A66 Northern Trans-Pennine Project

7.24 Applicant's Responses to the Examining Authority's Written Questions

**7.24 APPLICANT'S RESPONSES TO THE EXAMINING AUTHORITY'S
WRITTEN QUESTIONS**

Deadline:	Deadline 4
Planning Inspectorate Scheme Reference	TR010062
Application Document Reference	NH/EX/7.24
Author:	A66 Northern Trans-Pennine Project, Project Team, National Highways

**3.1. Appendix A: CA 1.9 Area for Replacement Slurry Tank and
Associated Indicative Swept Path Arrangement**

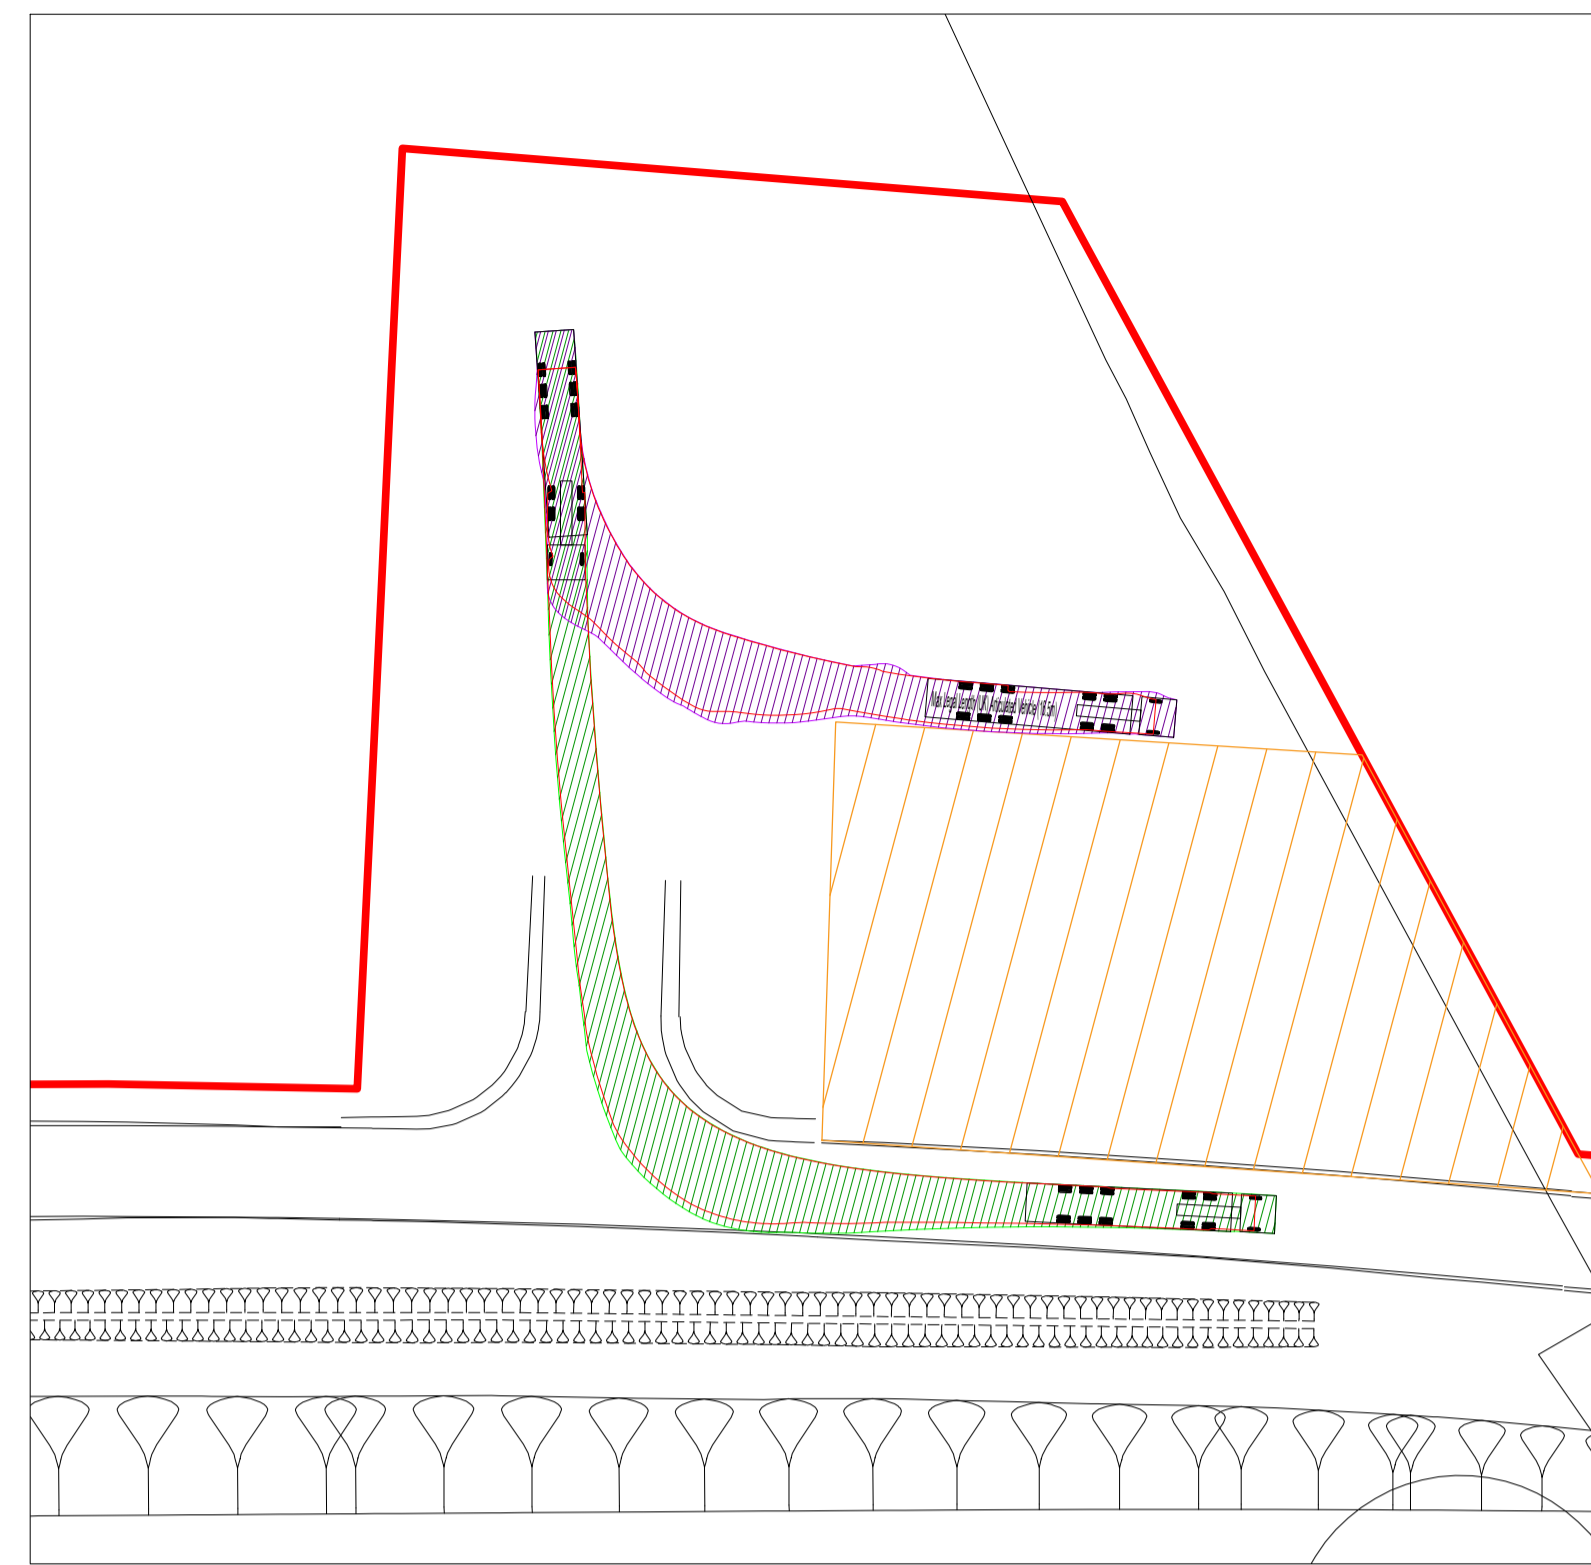
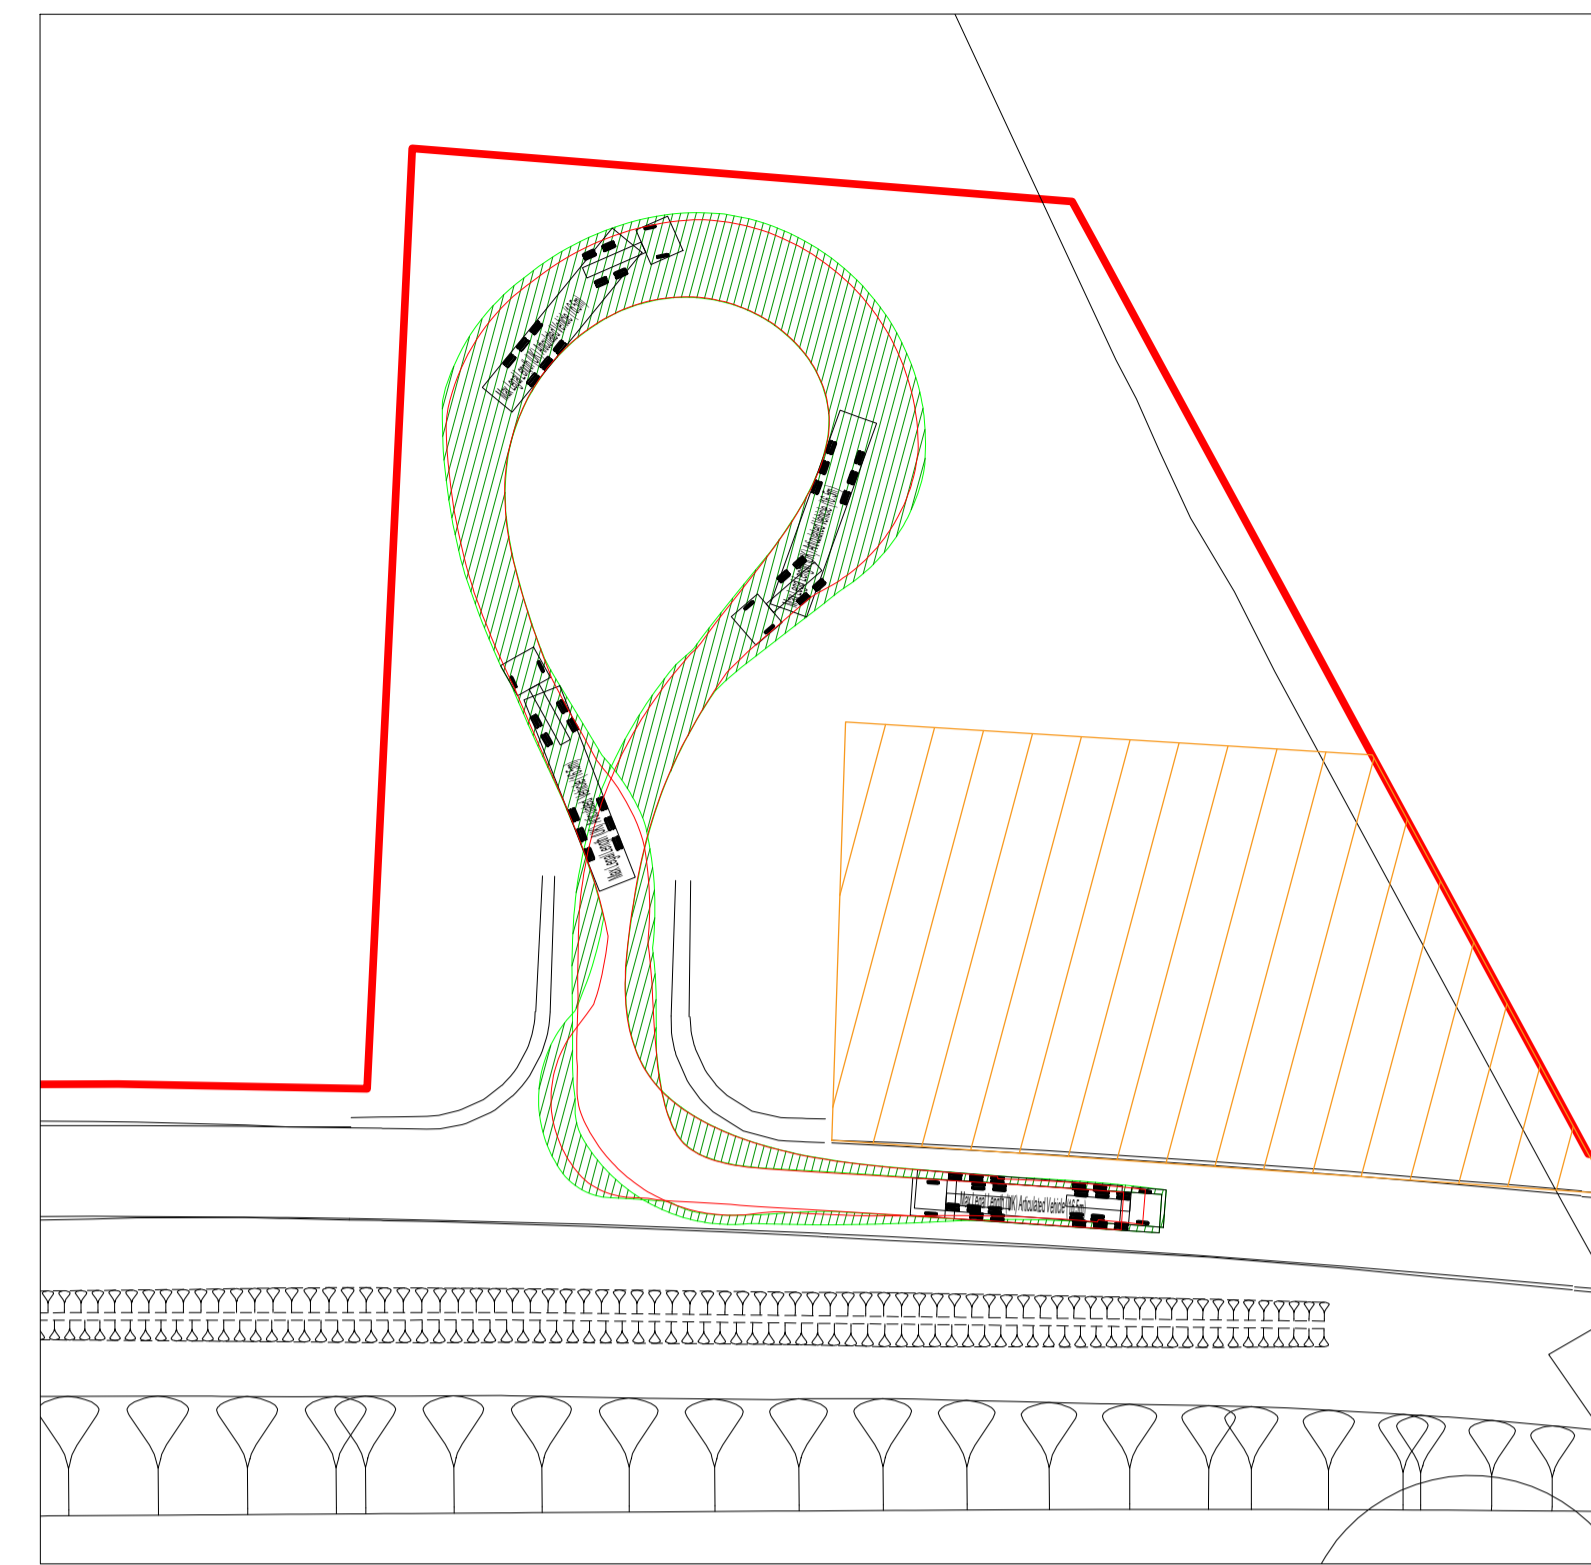
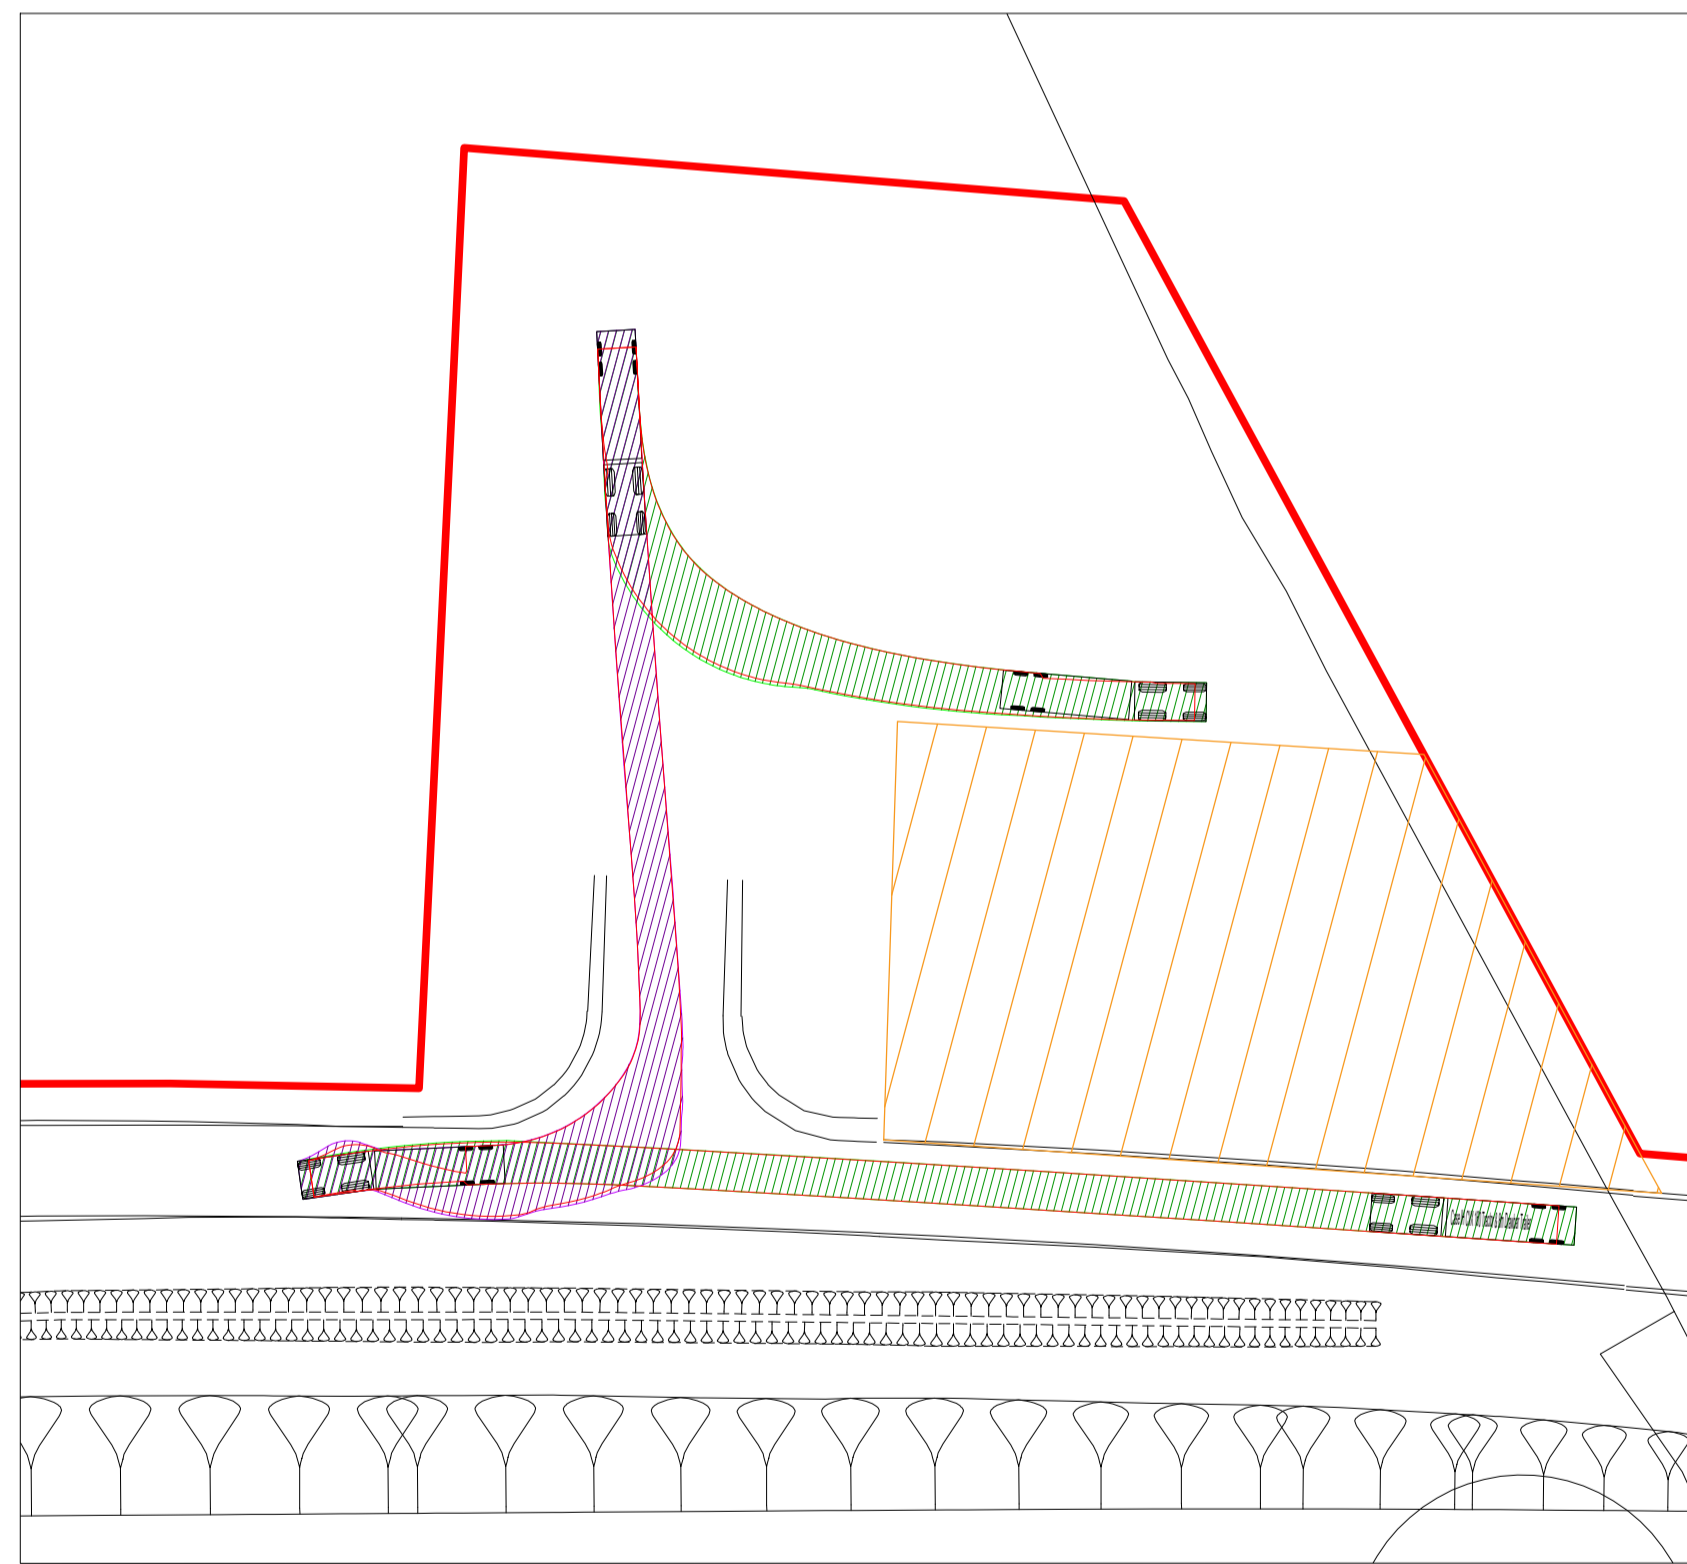
CA 1.9	Impact from CA	The Applicant	Explain how has the "additional space for vehicle turning" for W Austen Richardson Ltd been 'sized' in the context of vehicle dimensions and turning circles [REP1-136, para 2.6.1 and REP2-015, page 64]. Any response could be in a plan form.	Please see the plan within Appendix A to this document which shows an area for a replacement slurry tank and associated indicative swept path arrangement for vehicles to access and manoeuvre within the adjacent space (sketch ref:HE565627-AMY-HAC-S09-SK-CH-701205.). This is located on plot 09-01-19 as shown on Sheets 1 and 2 of the Stephen Bank to Carkin Moor Land Plans (APP-310). The area for the replacement tank has been sized based on the existing tank. Additional space is included, to provide for flexibility in locating the tank. Vehicle swept paths are based on a 16.5m articulated lorry and for a tractor/ trailer combination. Options have been shown for the vehicles to drive in and turn around in one movement or to adopt a stop and reverse manoeuvre. Further discussions will be required with the landowner as to the preferred option and sizing of the tank and turning area to allow refinement where possible, but it is clear from the plan provided in Appendix A that there is sufficient space to accommodate the desired vehicle movements.
